ALAMEDA COUNTY HEALTH CARE SERVICES AGENCY

November 20, 2012

Subject: Work Plan Approval for SLIC Case RO0003079 and GeoTracker Global ID T10000003401, Byron Power Company, 4901 Bruns Road, Byron, CA 94514

Attachment 1 - Recommended Well Locations

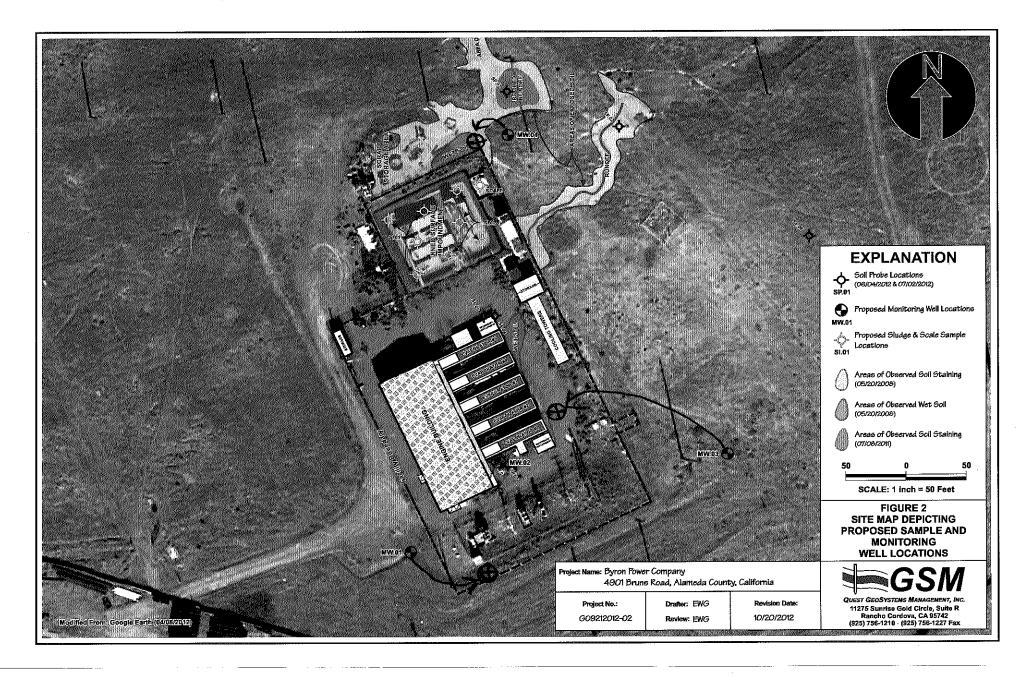
1. Recommended Well Locations. ACEH requests modifications for three of the proposed monitoring well locations based on the most likely hydraulic gradient for the site, which is to the northeast. Recommended locations are shown on Attachment 1 to this correspondence. After reviewing these recommended locations, please contact Jerry Wickham to refine these locations or propose further modifications to the well locations if necessary.
